Relevant Portions of Duke Energy's  
Response to NRC Request for  
Additional Information Submitted  
to the NRC, November 3, 2003

NUCLEAR REGULATORY COMMISSION

Docket No. 50-413/414-OLA Official Ex. No. 2  
 In the matter of Duke Catawba  
 Staff \_\_\_\_\_ IDENTIFIED 7/14/04  
 Applicant ✓ RECEIVED 7/14/04  
 Intervenor \_\_\_\_\_ REJECTED \_\_\_\_\_  
 Cont'g Off'r \_\_\_\_\_  
 Contractor \_\_\_\_\_ DATE \_\_\_\_\_  
 Other \_\_\_\_\_ Witness \_\_\_\_\_  
 Reporter Palmer Adams

Figure Q13-1  
Loop Noding Diagram

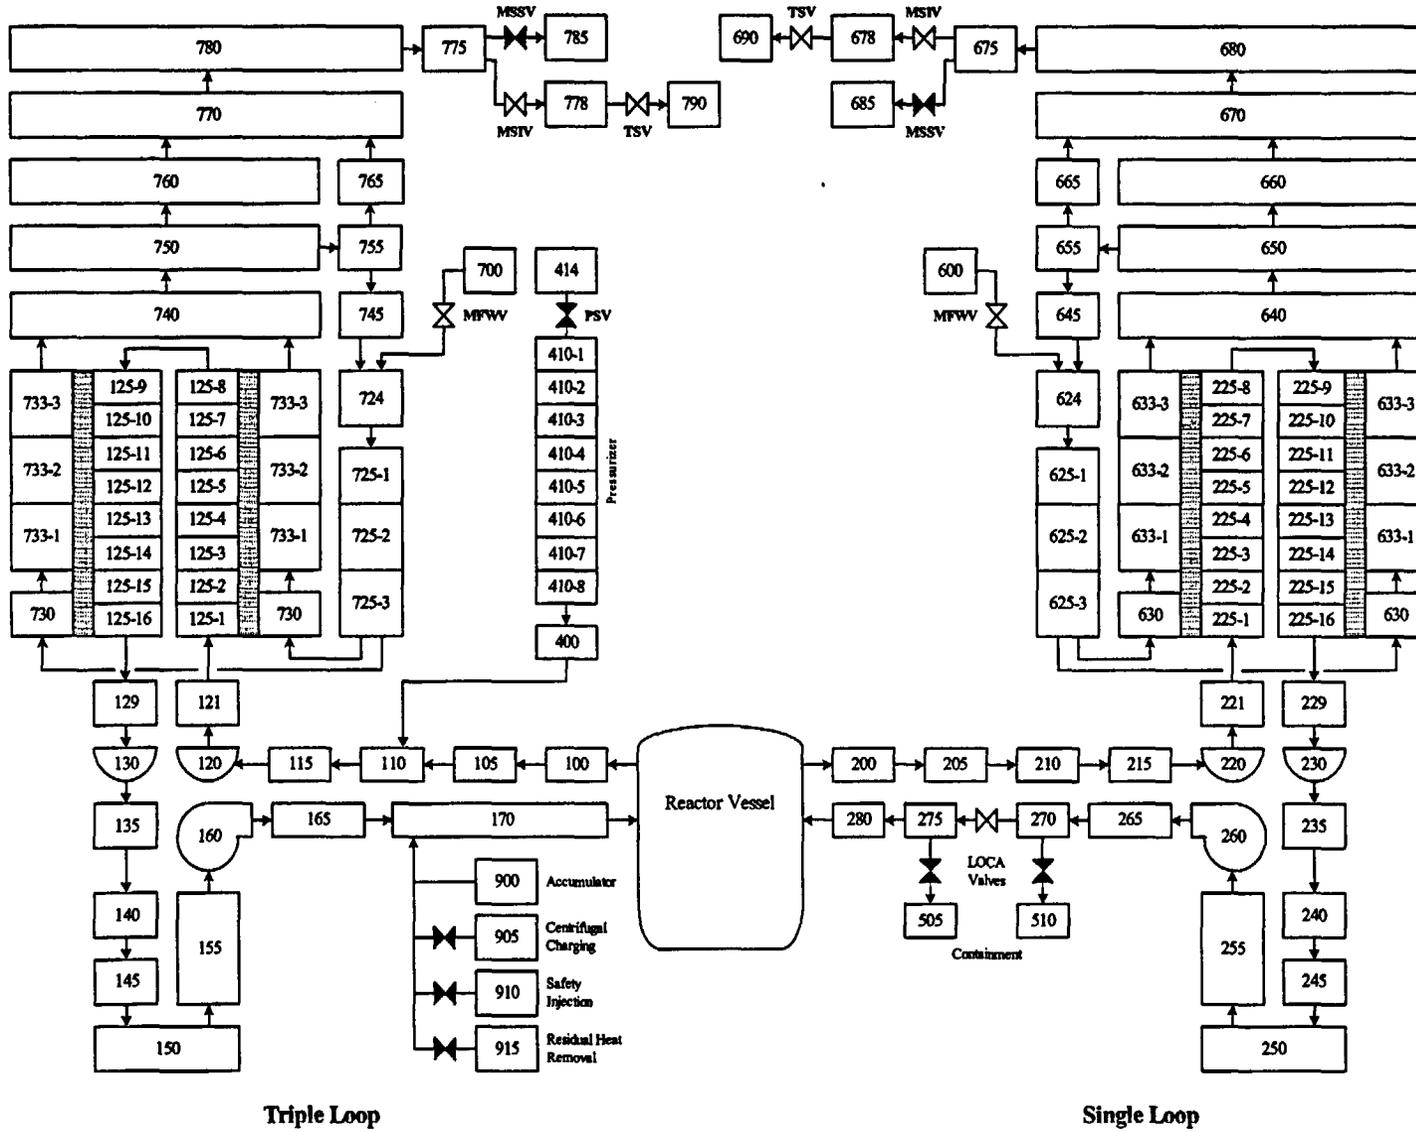
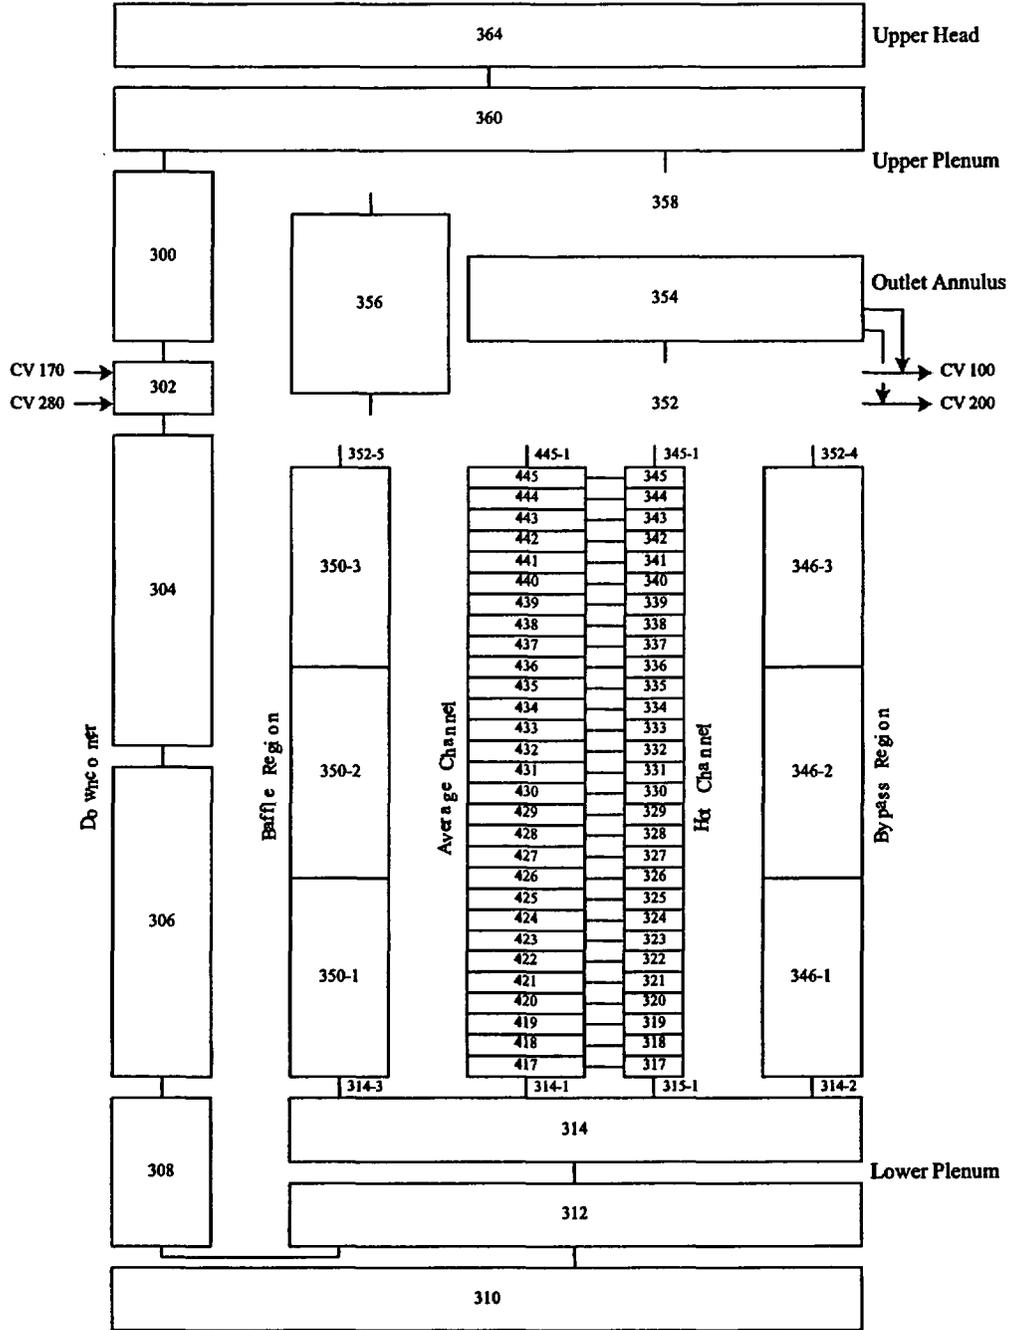
13. To allow the NRC staff to perform confirmatory analysis, please provide both the McGuire and Catawba loss-of-coolant accident (LOCA) input decks for the low enriched uranium (LEU) as well as the MOX fuel rods. Provide the decks in an electronic format, including nodalization diagrams.

Figures Q13-1 and Q13-2 are node diagrams for the decks. Figure Q13-1 shows the loop node arrangement while Figure Q13-2 shows the reactor vessel node arrangement. Figure 3-5 of Attachment 3 to Reference Q13-1 provides some additional detail specific to the core region.

Figure Q14-1  
 MOX Fuel Lead Assembly Total Core Peaking Factor

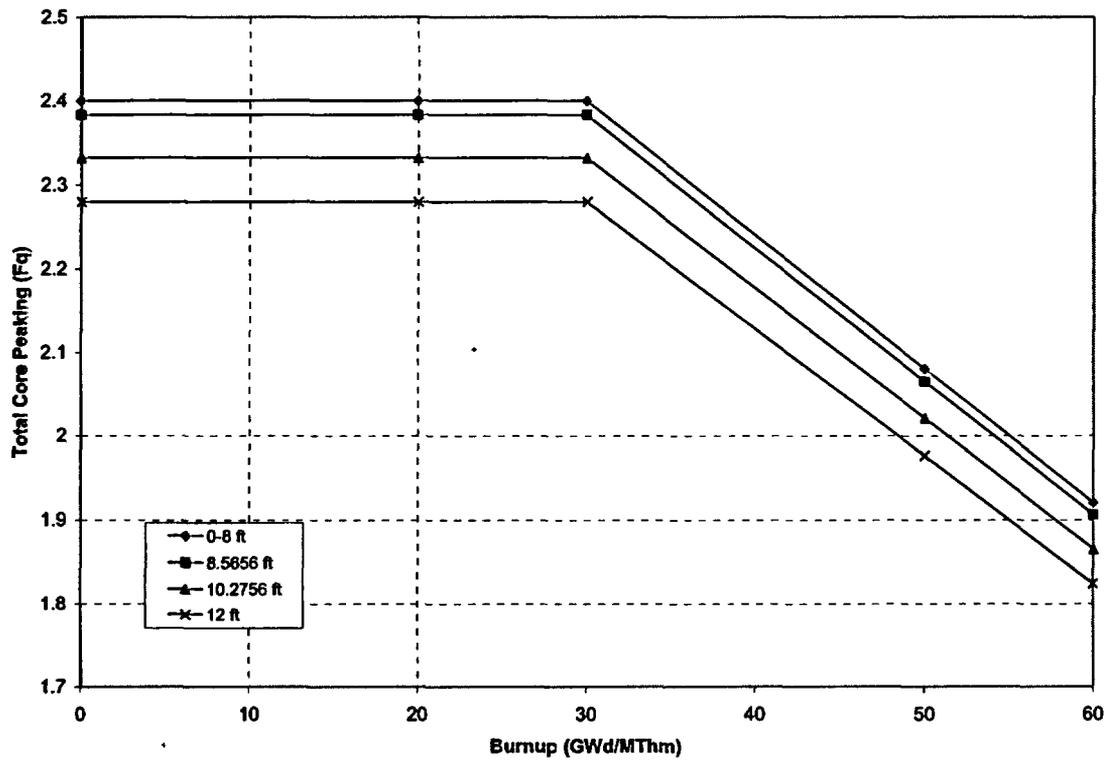
14. Provide the reference to the best estimate LOCA model noted in section 3.7.1.7.

A summary of the sensitivity cases is provided in Table Q14-1. The resulting LOCA peaking requirements for the MOX fuel lead assemblies are shown in Figure Q14-1. These peaking requirements will assure that the MOX fuel will comply with the regulatory limits for LOCA as provided in the response to Reactor System RAI Question 12.

Figure Q21-1  
 Thermal Conductivity Comparison for MOX and LEU Fuel  
 (Fuel porosity of 0.0479)

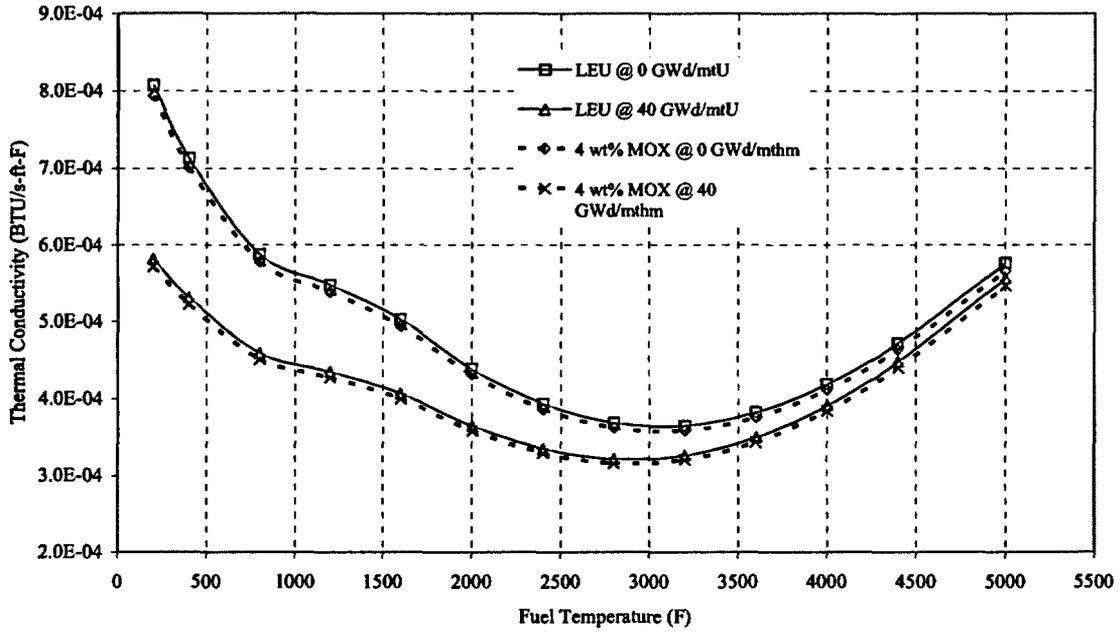
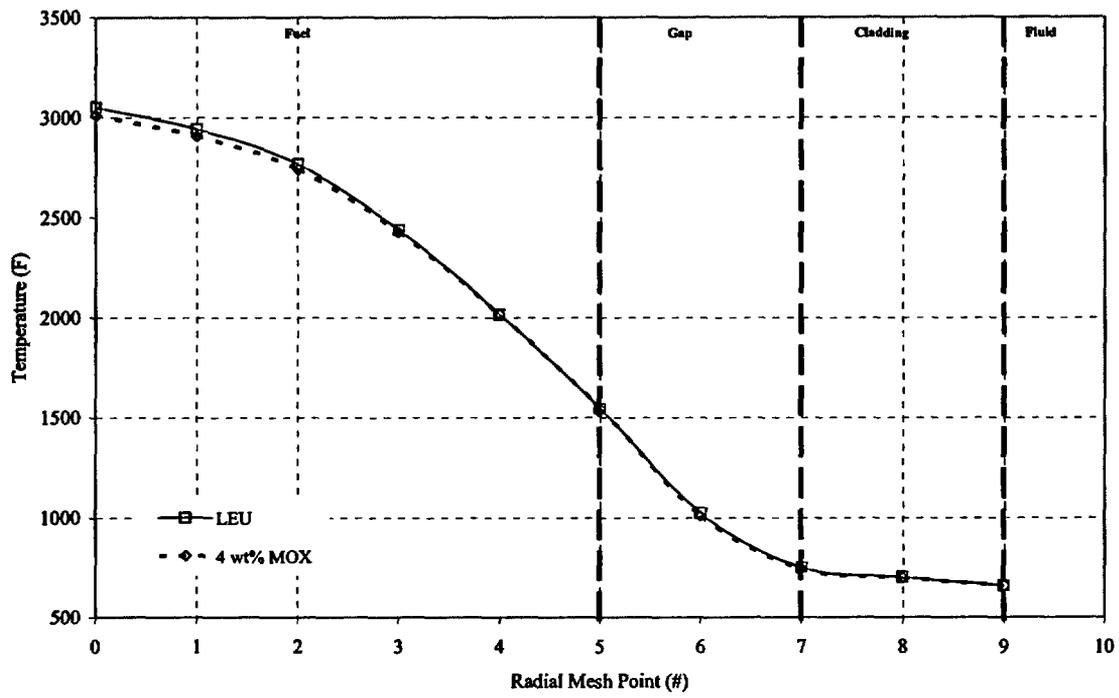
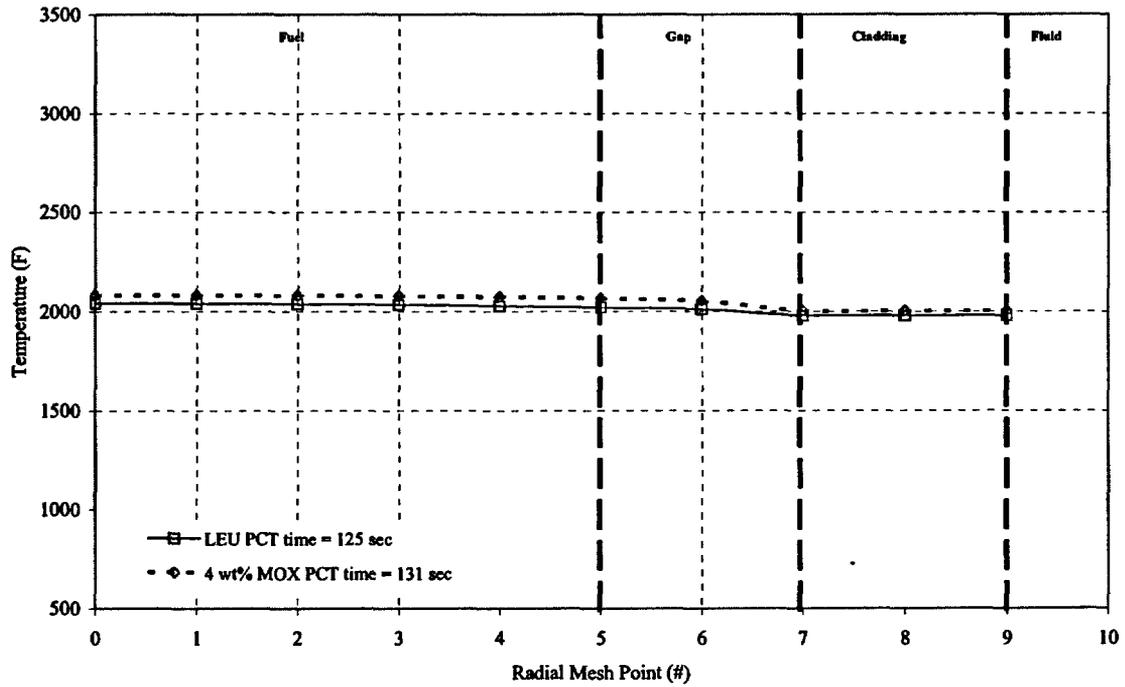
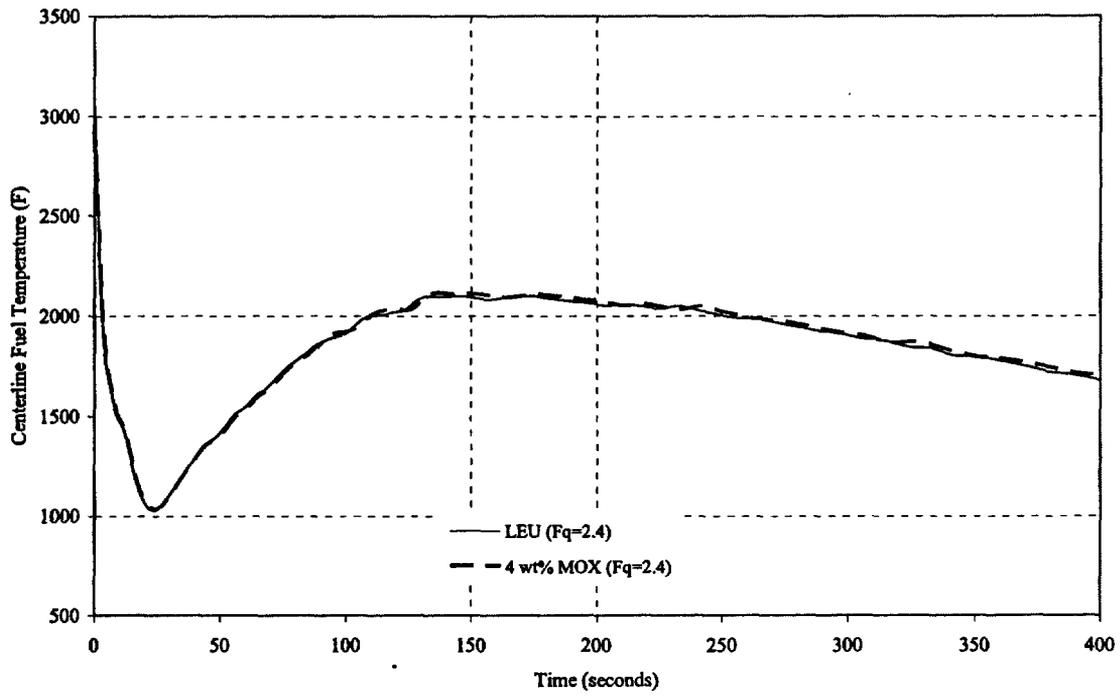
21. How does the lower fuel conductivity of the MOX fuel impact the maximum pellet centerline temperature during a LOCA as compared to LEU fuel? Please provide a qualitative and quantitative discussion of the differences.

There is only a slight difference in the fuel pellet conductivity between MOX fuel of the lead assembly design and plutonium concentration and comparable LEU fuel. Figure Q21-1 compares the thermal conductivity for MOX fuel pellets of the lead assembly design to comparable LEU fuel pellets for both un-irradiated fuel and fuel irradiated to 40 GWd/MThm. The thermal conductivity values shown in Figure Q21-1 are from the fuel performance code COPERNIC (Reference Q21-1). COPERNIC has been approved by NRC for use with LEU fuel and is under review for MOX fuel applications. Although thermal conductivity values in Figure Q21-1 change with burnup for both MOX fuel and LEU fuel, the offset, approximately two percent, is constant.

The analyses presented in Section 3.7.1 of Attachment 3 to the license amendment request (Reference Q21-2) directly compare the effect of the MOX to LEU offset in conductivity in conjunction with the other differences in the fuel pin designs. Figures Q21-2 and Q21-3 provide a fuel pin temperature profile comparison between MOX and LEU fuel pellets at the accident initial conditions and at the approximate time of peak cladding temperature. As expected, there is little difference in the temperature distributions between the two fuel types. Figure Q21-4 provides the evolution of the centerline fuel temperatures with time for the MOX and LEU fuel at the location of peak cladding temperature. The two fuel temperatures differ slightly during the course of the transient. The variation is attributed to fuel pellet thermal conductivity and to other differences in the fuel pin design. As an example, the LEU fuel pin has a higher pre-fill pressure than the MOX pin. The higher pressure increases the hoop stress resulting in a slightly lower calculated rupture temperature and earlier calculated rupture time. Combined with all of the models interacting to determine the cladding and pellet temperatures the LEU fuel centerline temperature is 40°F cooler at the time of peak cladding temperature.

Figure Q25-1  
Multipliers on RELAP5 to Match COPERNIC Gap Thermal Model

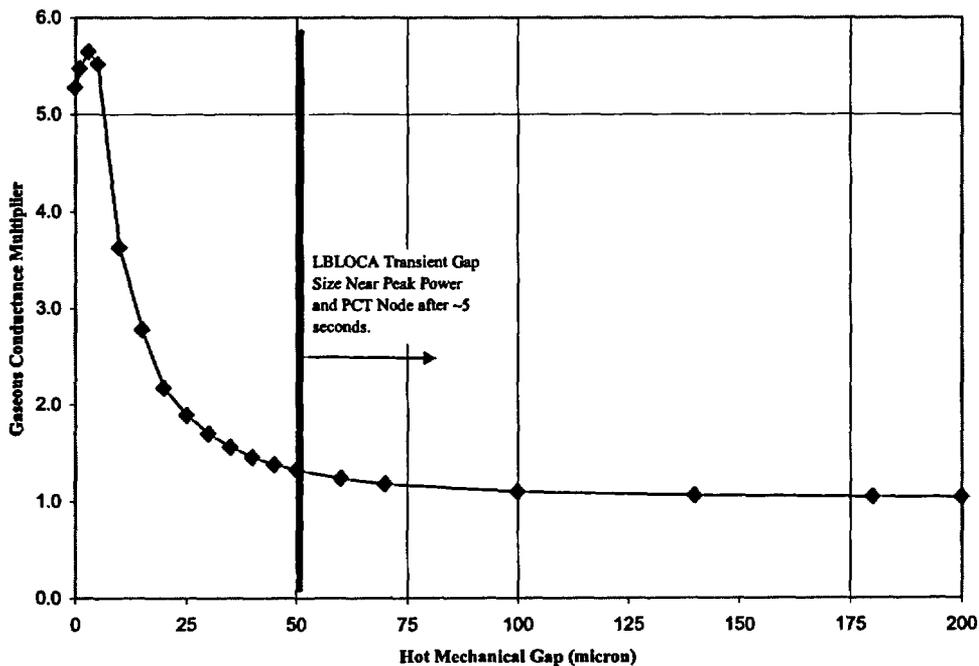
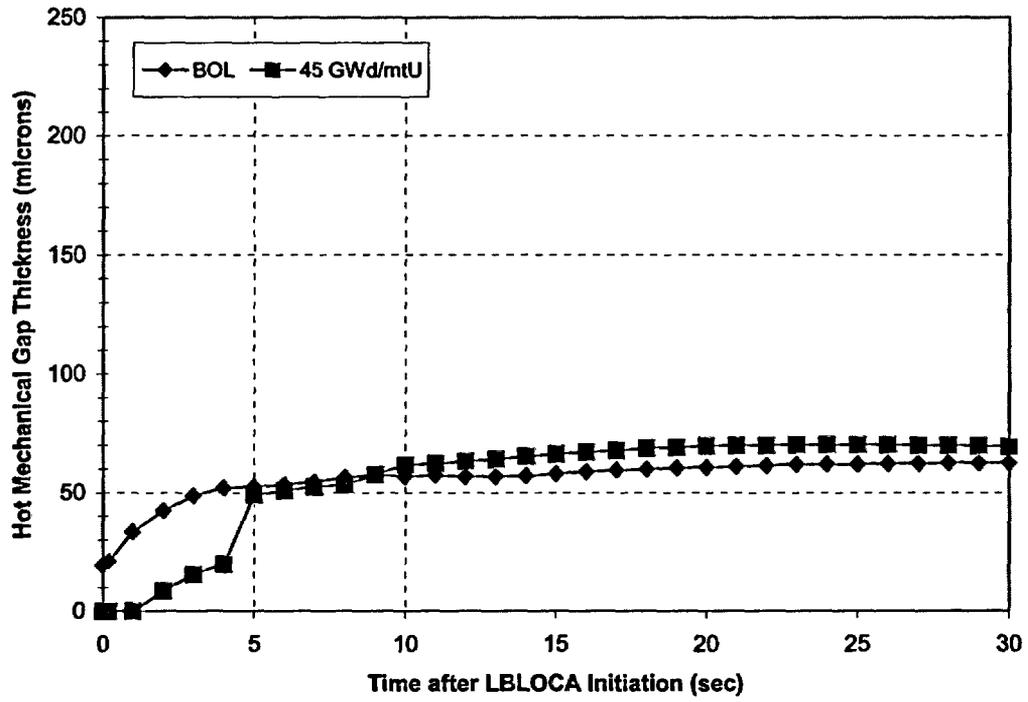
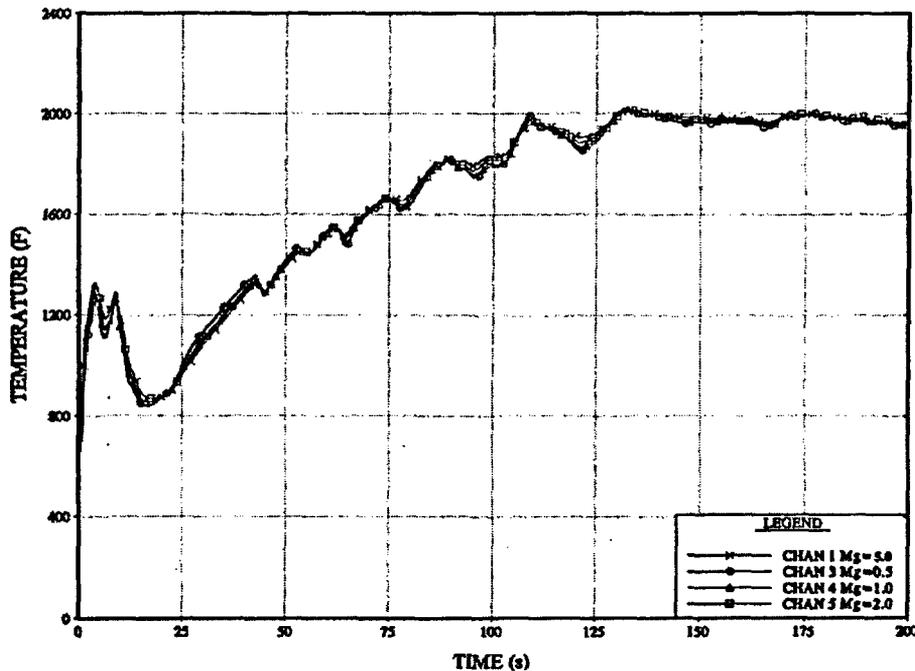
25. Section 3.7.1.1.4 discusses RELAP5 initialization, stating that the core model will not be in steady state at transient initialization. Since a false declared steady state can lead to errors from an imbalance, please provide justification for why the RELAP5 model will not be in steady state at transient initiation and how steady state conditions for initialization are assured.

The results of the evaluation determined that RELAP5/MOD2-B&W and COPERNIC provide similar gap conductance results when the gap thickness is relatively large. However, there was a noticeable difference in the gap conductance when the gap is small. The accounting of gaseous conductance for gas space between rough surfaces in contact differs between the two codes. Although a gaseous conductance multiplier would allow RELAP5/MOD2-B&W to generate an initialization that matched the uncertainty-adjusted COPERNIC fuel temperatures, the multiplier value would be large for small gaps and applicable only so long as the gap remains small.

Figure Q25-2 demonstrates the transient gap thickness for LBLOCAs initialized at BOL and 45,000 MWd/MtU. For BOL, the gap is initially open and the increased transient gap does not significantly alter the gaseous conductance. A multiplier of between one and two could be applied without significantly affecting the transient simulation. However, for exposed fuel, the initialization multiplier based on the gaseous conductance model may be as high as six and would only be reduced to between two and three by application of the COPERNIC fuel pellet temperature uncertainties. Such a multiplier would quickly become inappropriate as the gap opens during the transient. Because RELAP5/MOD2-B&W does not have the ability to modify the gap gaseous conductance multiplier during the transient, and it is apparent that the multiplier should be less than two after about five seconds, the gaseous conductance multiplier approach was deemed inappropriate for COPERNIC-based LOCA calculations.

In conclusion, the system model in the MOX demonstration cases was initialized to steady state at the desired peaking conditions and the initial fuel temperatures were set to the COPERNIC-predicted temperatures with appropriate uncertainties added. The method ensures an appropriate specification of the initial fuel stored energy and a proper calculation of the gap conductance during a LBLOCA transient.
